### C. Second Response to Environment Agency

**RE: Stage Brewery – River Wall**

I am writing in response to your comments dated 18<sup>th</sup> September 2018 in relation to the proposals for a new river wall at the Stag Brewery Site (planning reference: 18/0547/FUL). Please see below the information in response to your comments.

## E. Updated Defence Drawings – Ship Lane

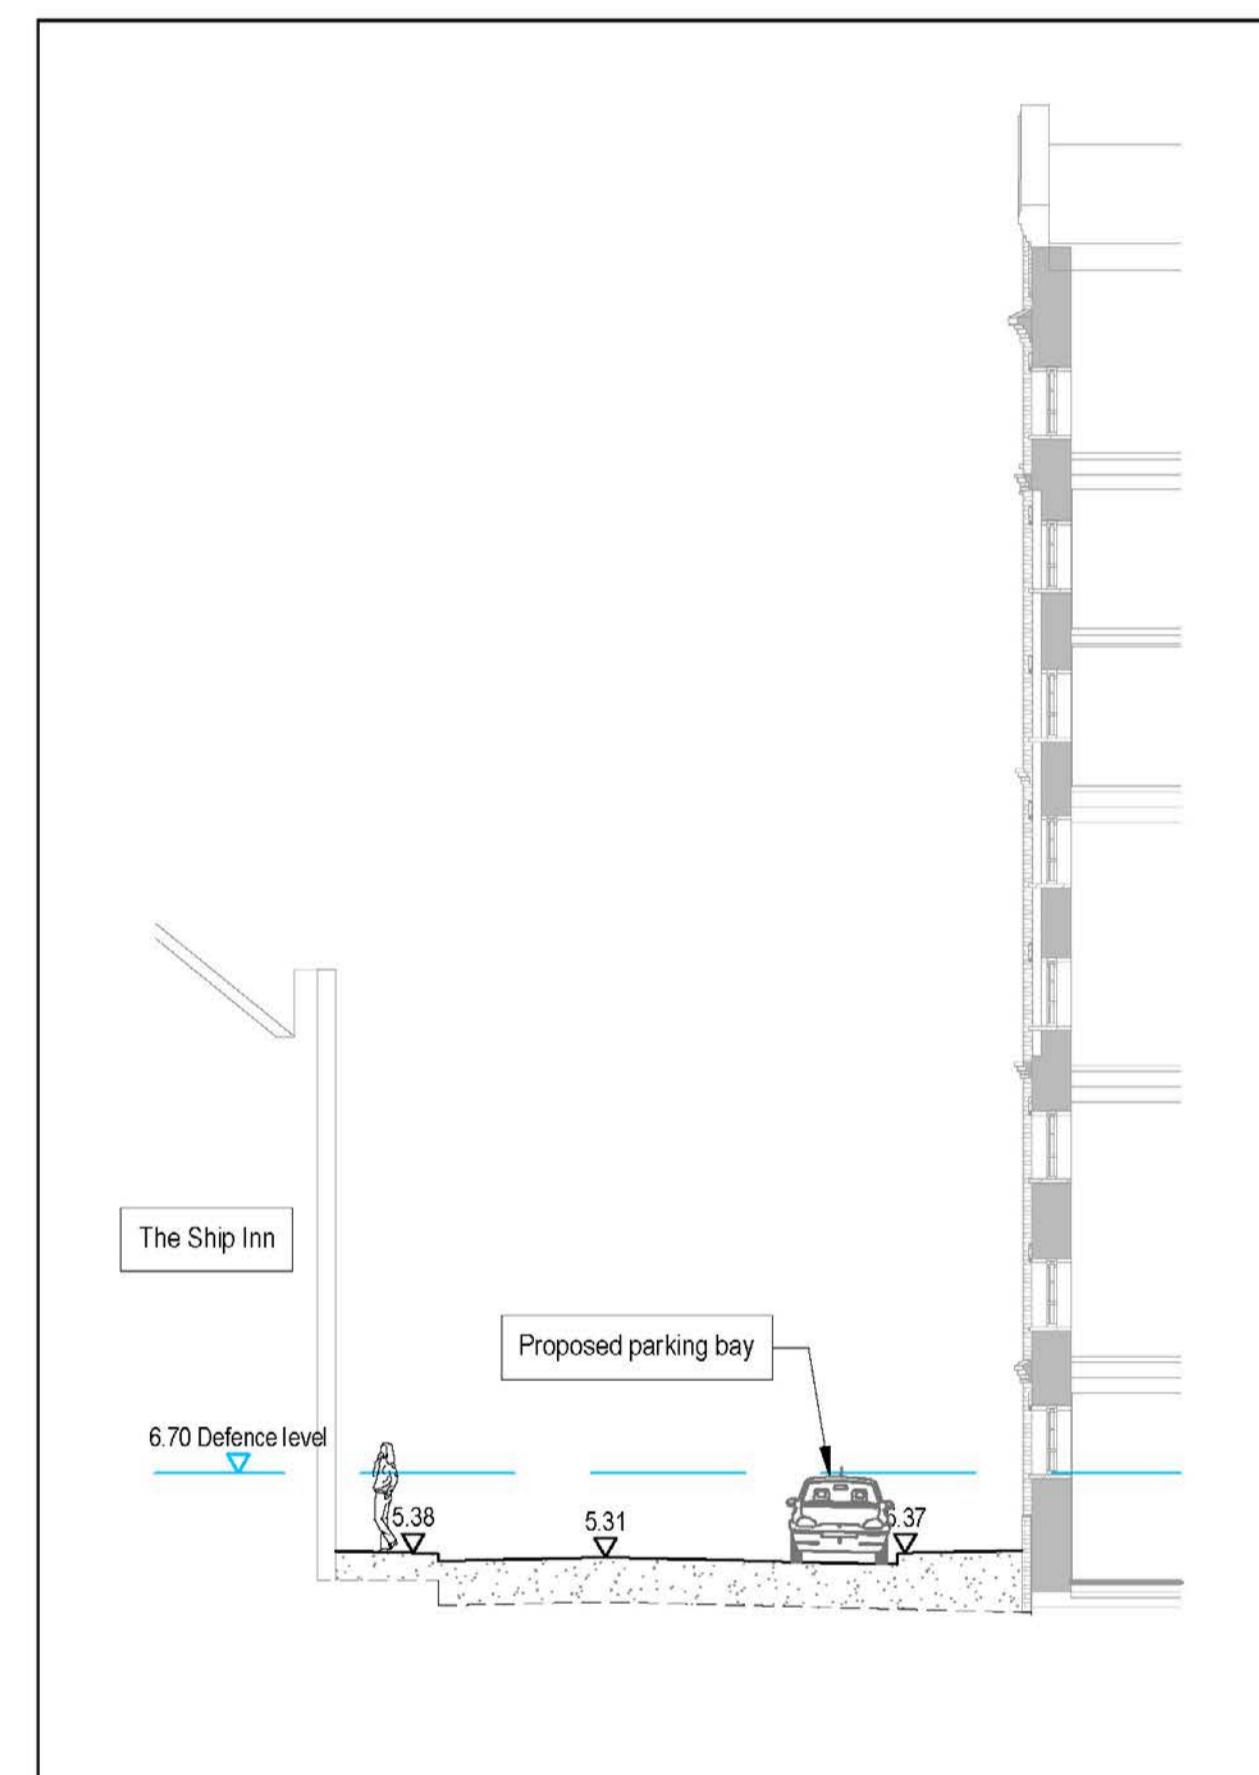
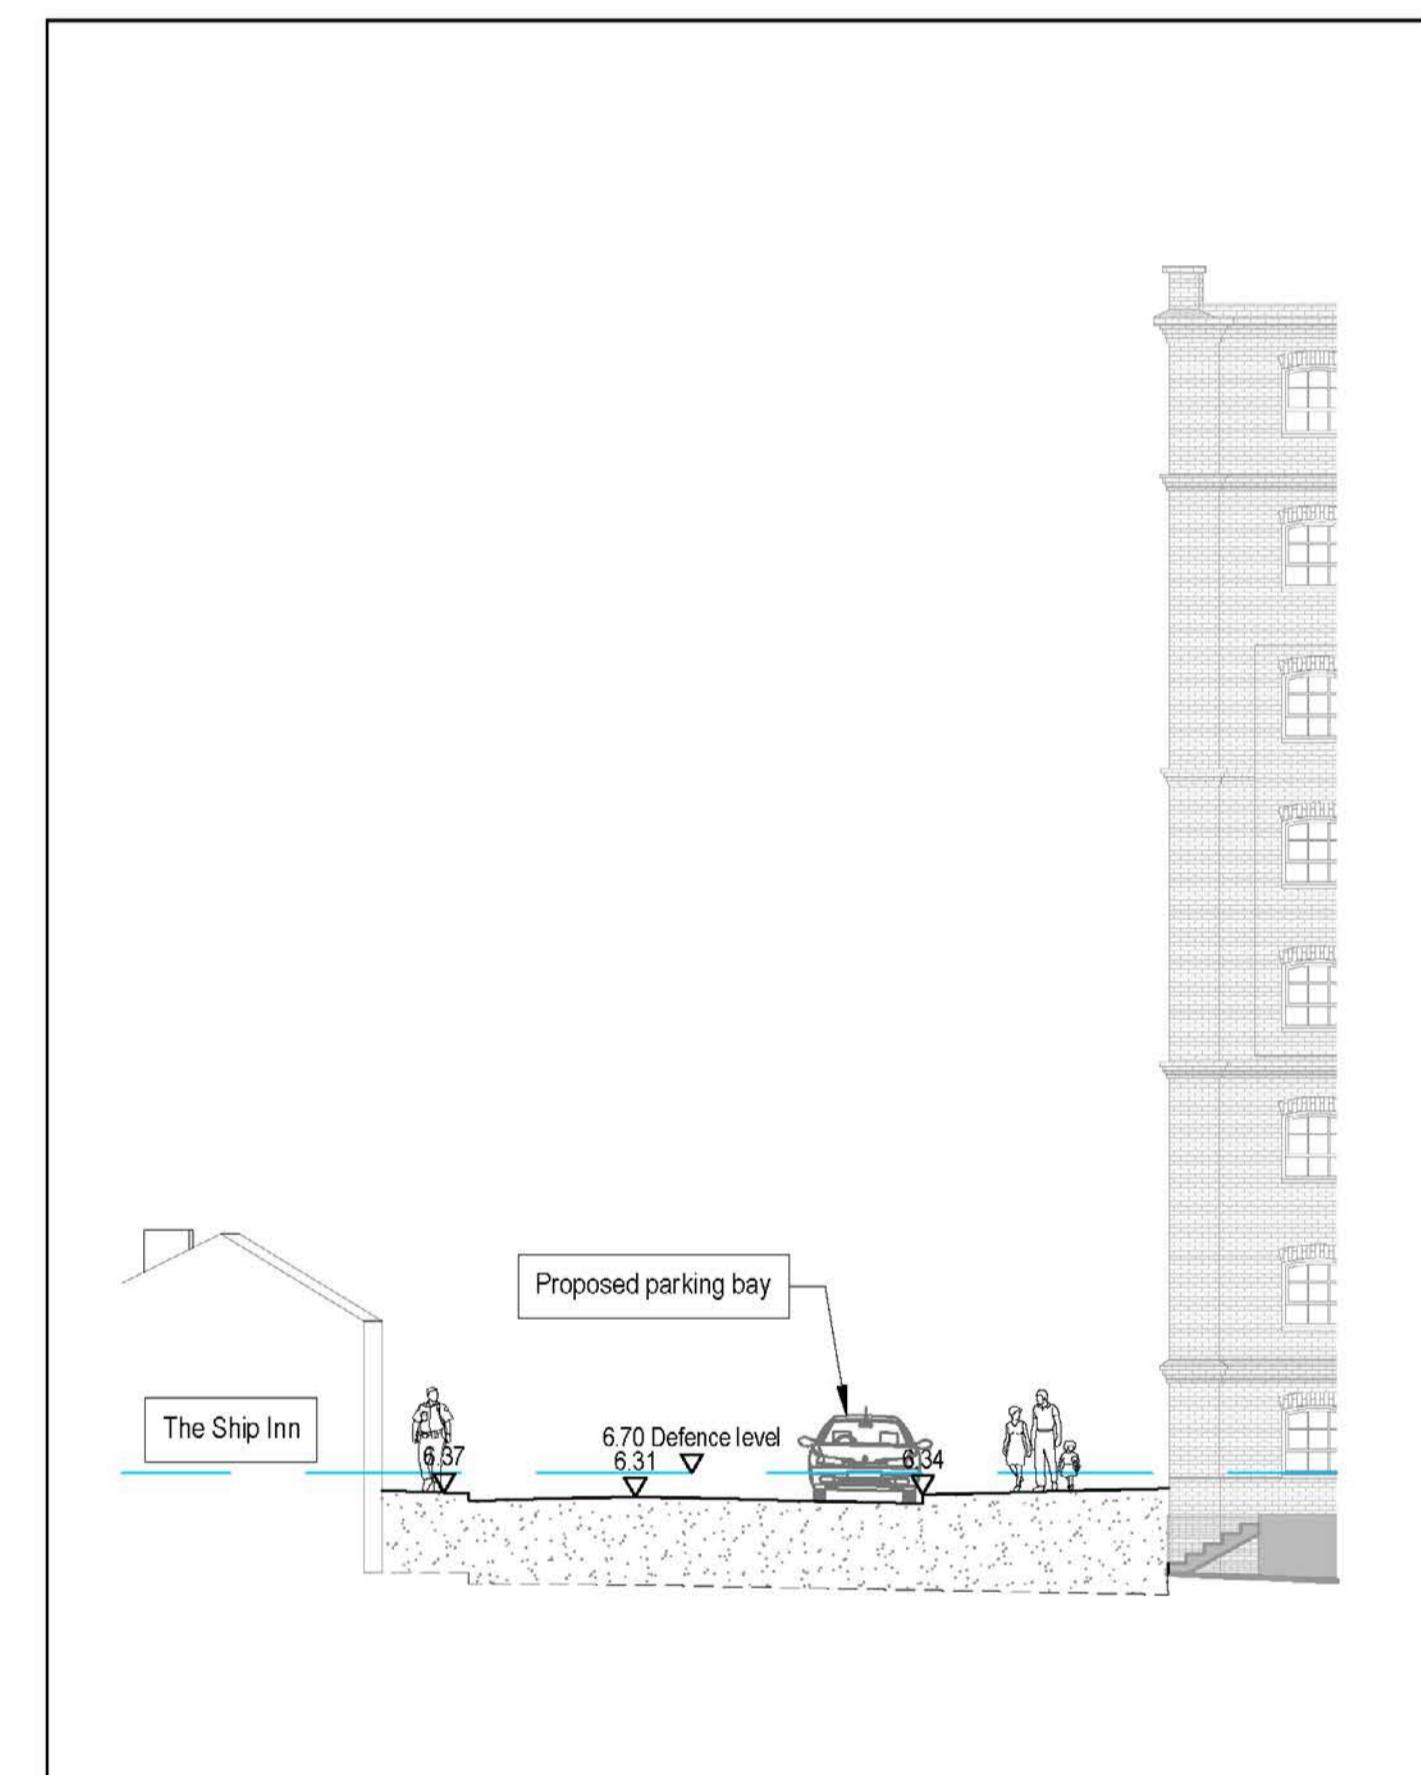
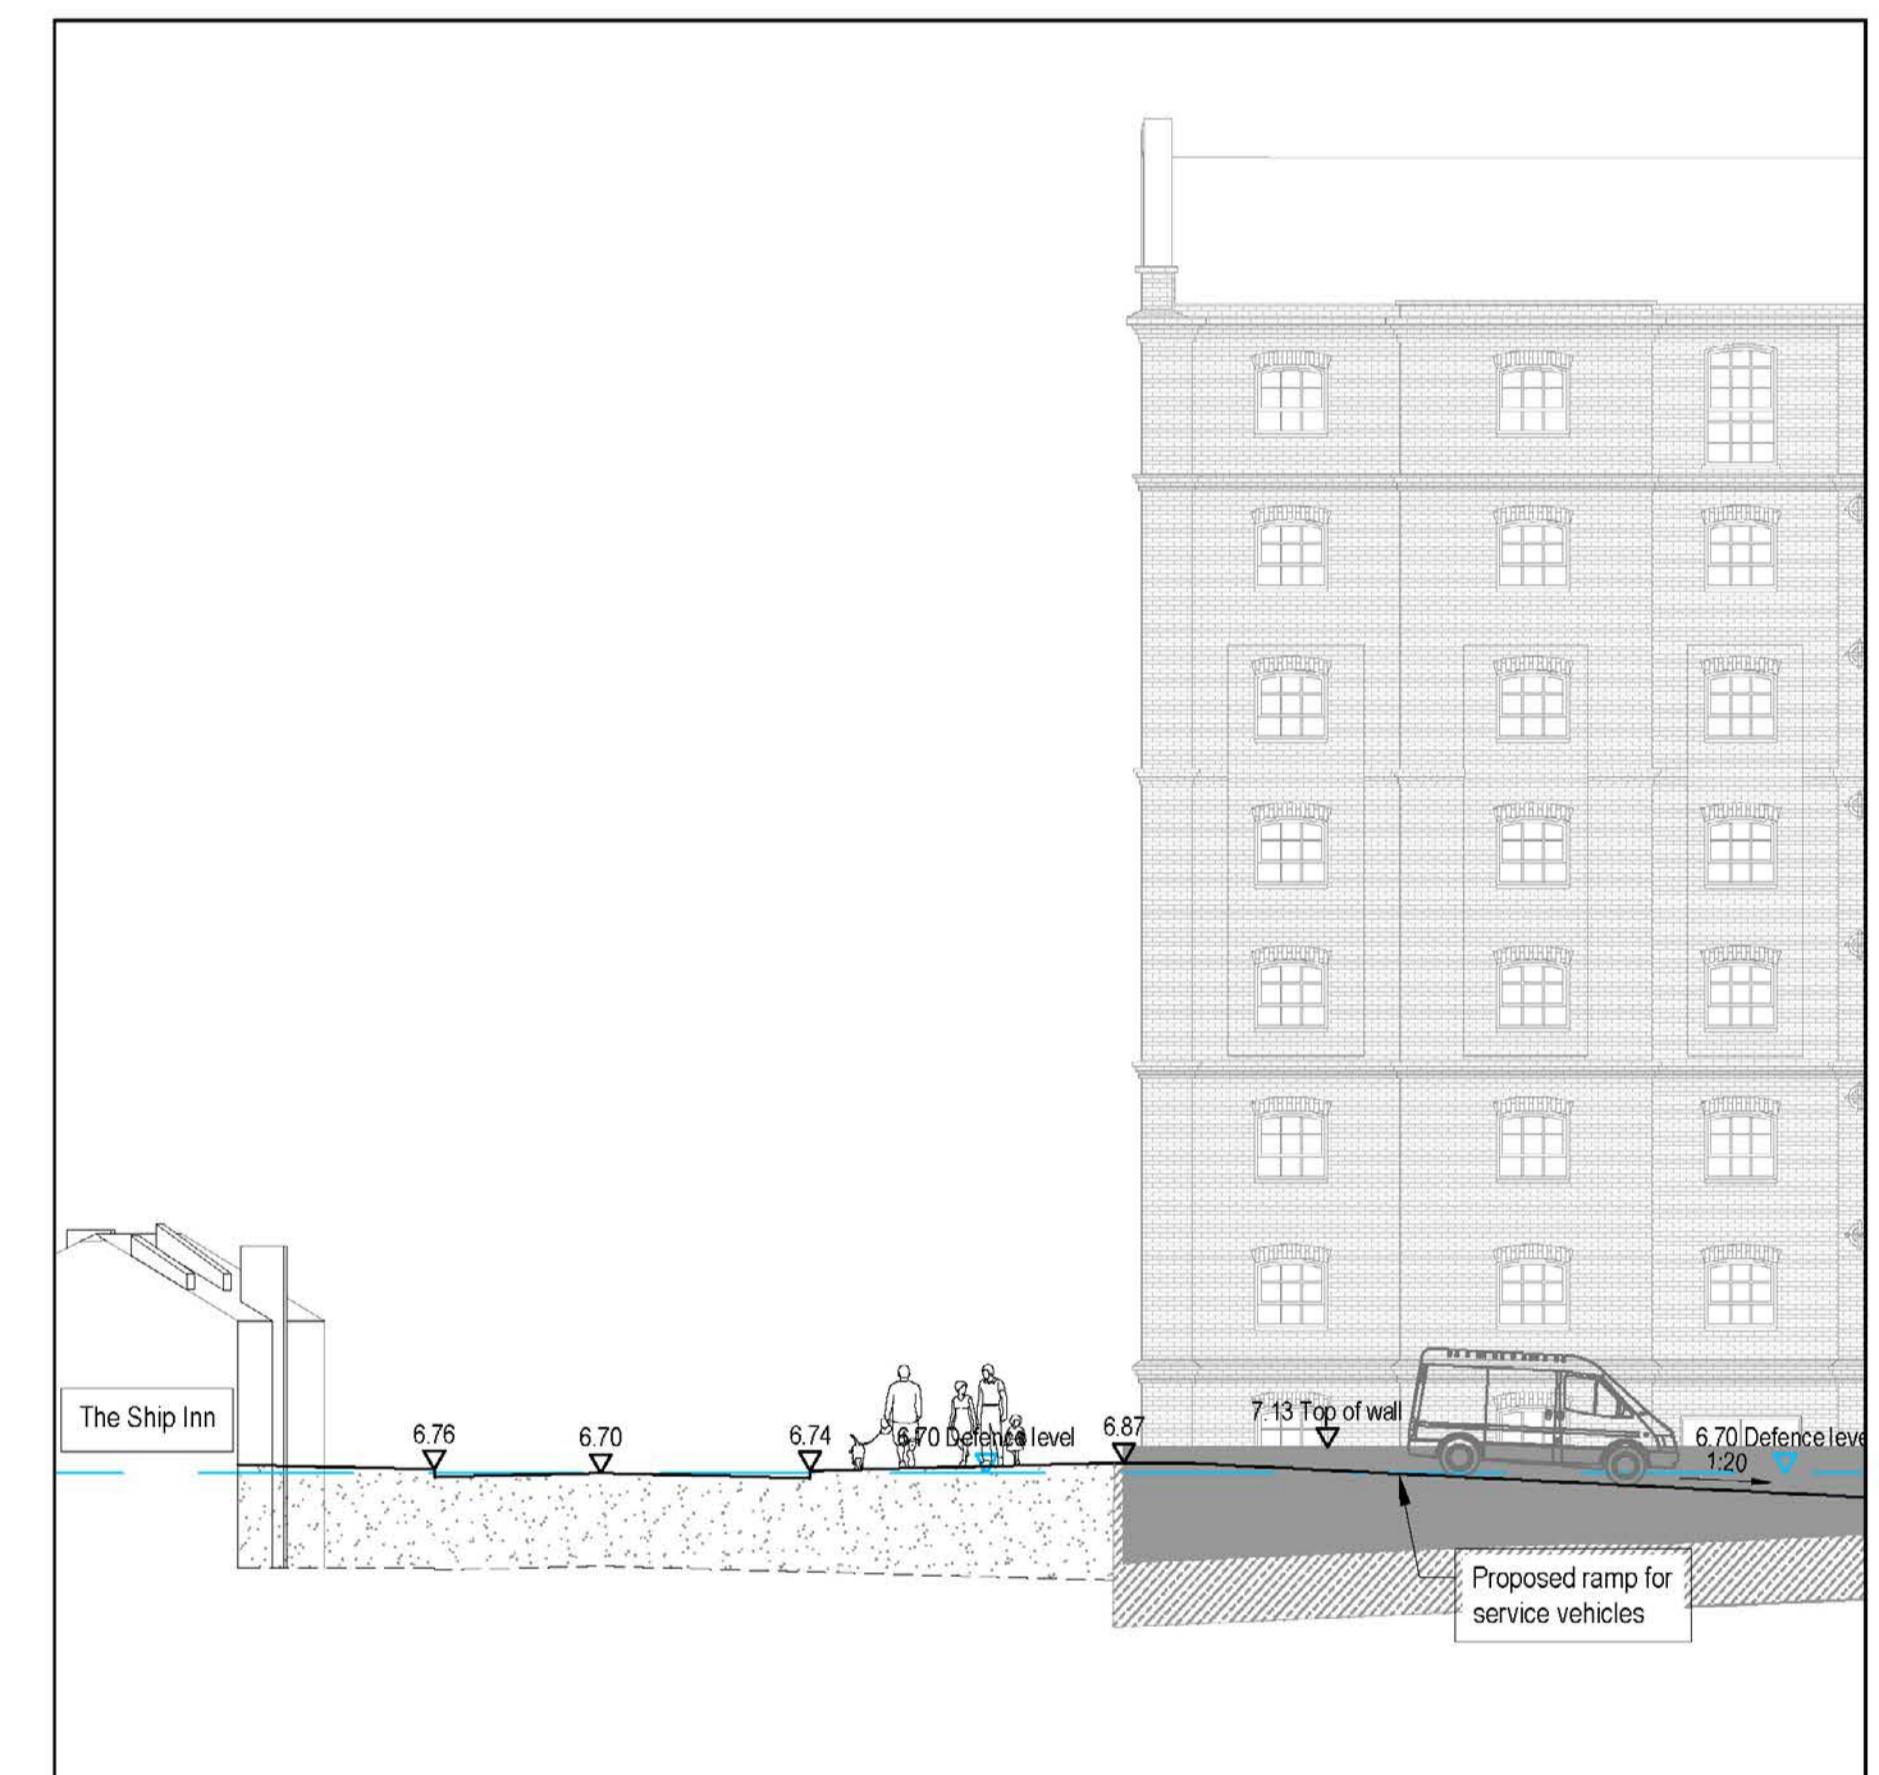
**Query 5) – Ship Lane and Bull Alley** – Bull Alley, and the flood boards for this location are within the redline boundary of the application. Irrespective of ownership, developer will have to demonstrate both the residual lifespan and TE2100 crest level raising for all tidal flood defences within their red-line boundary. Our preference would be for the flood boards to be removed and a passive (static) flood defence installed. Regarding Ship Lane, we appreciate the applicant may not be the freeholder of this land, and therefore may not be liable to ultimately provide the flood defence across the road. However, the applicant is responsible for demonstrating how all flood defence line within their redline boundary, will be treated in light of TE2100 raising requirements and how these will tie in with the

We appreciate that a passive defence is always preferable, however the practicalities of raising Ship Lane itself mean that this option is not suitable. It is correct that the level of Ship Lane does rise to circa 6.1m AOD and that at this point a raise of only 600mm would be required. However, this would result in the River Thames Defence line moving back along Ship Lane in a southerly direction which in turn will allow flood water to flow further down Ship Lane than it would currently do. As a result, the defence height of 6.7m AOD would then need to be in place on either side of Ship Lane. This would render the currently proposed active frontages along Ship Lane unfeasible and would create a narrow corridor with walls on either side.

If constraints mean that passive defences are not possible to the full TE2100 height of 6.7m AOD then the EA would want the height of any gate limited to minimum it needs to be (i.e. raised ground provides protection to say 6.0m AOD and then a gate would only need to be 0.7m high).
